Access Compliance Report

Public Rights-of-Way

(Pedestrian Signals)

Intersection ID: N/A	Main Street:	Cross Street: N/A	Location: N/A
ADA ID: 2CFCF518FF7E	Signal Type: Two Push Buttons-Non APS	Overall Compliance: No	Severity Score: BTN 1:N/A BTN 2: N/A No BTN: N/A
Codes/Mitigation Info/Possible Solution		Field Measurements/Component Compliance

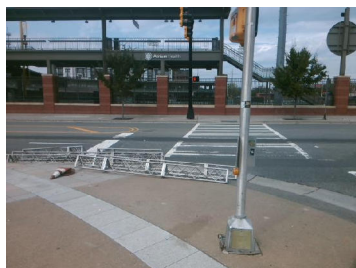
PROW/ADA: TMUTCD 4e.08, R404.2, R404.3, R406.2

Yes	B 1 Clear Xing Direction?	ClearlyMarked	Yes	B 2 Clear Xing Direction?	ClearlyMarked
	B 1 Crossing Direction	To NE		B 2 Crossing Direction	To NW
Yes	B 1 DistanceTo XWalk (in)	43.0	Yes	B 2 DistanceTo XWalk (in)	0.0
No	B 1 DistanceTo Curb (in)	120.0	No	B 2 DistanceTo Curb (in)	144.0
Yes	B 1 Diameter (in)	2.0	Yes	B 2 Diameter (in)	2.0

Possible Solutions: Replace Signal Push Button With APS Button on New Post. Remove & Relocate Sign.
